Access Compliance Report

Public Rights-of-Way

Intersection ID: 9447	Main Street: ATANDO_AV	Cross Street: N_TRYON_ST	Location: NE
ADA ID: 77BC05E87D53	Ramp Type: Perp	Initial Pass/Fail: Fail	Overall Compliance: No
		Severity Score: 8.75

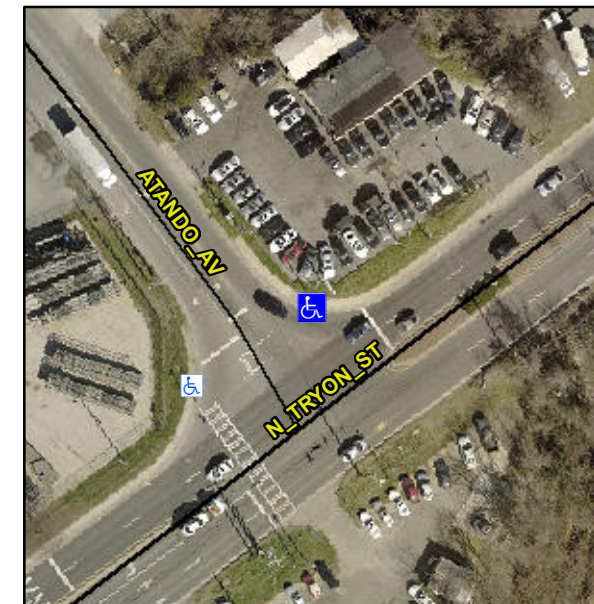
Not Found, R304.5.1

Compliance	Description	Data	Compliance	Description	Data
N/A	Ramp Length (in)	60.0	Yes	Ramp Slope (%)	7.3
No	Ramp Width (in)	41.0	Yes	Ramp XSlope (%)	0.6
N/A	Flare Type LT	N/A	N/A	Flare Type RT	N/A
N/A	Flare Slope LT (%)	N/A	N/A	Flare Slope RT (%)	N/A
N/A	Flare Traversable LT?	N/A	N/A	Flare Traversable RT?	N/A
N/A	Landing Length (in)	N/A	N/A	DWS Provided?	N/A
N/A	Landing Width (in)	N/A	N/A	DWS Contrast?	N/A
N/A	Landing Slope (%)	N/A	N/A	DWS Length (in)	N/A
N/A	Landing X Slope (%)	N/A	N/A	DWS Full Width?	N/A
N/A	Landing Curb? (Y/N)	N/A	N/A	DWS Offset (in)	N/A
N/A	Shared Landing?	N/A			
N/A	Gutter Ponding?	N/A	N/A	Gutter Slope (%)	N/A
N/A	Gutter Lip Ht (in)	0.5	N/A	Gutter X Slope (%)	N/A
N/A	Painted X Walk1?	Yes	N/A	Painted X Walk2?	N/A
	X Walk 1 Direction	To SW		X Walk 2 Direction	N/A
N/A	X Walk 1 Width (in)	111.0	N/A	X Walk 2 Width (in)	N/A
	X Walk 1 Slope (%)	3.1		X Walk 2 Slope (%)	N/A
	X Walk 1 X Slope (%)	3.4		X Walk 2 X Slope (%)	N/A

Remove & Replace Entire Ramp.
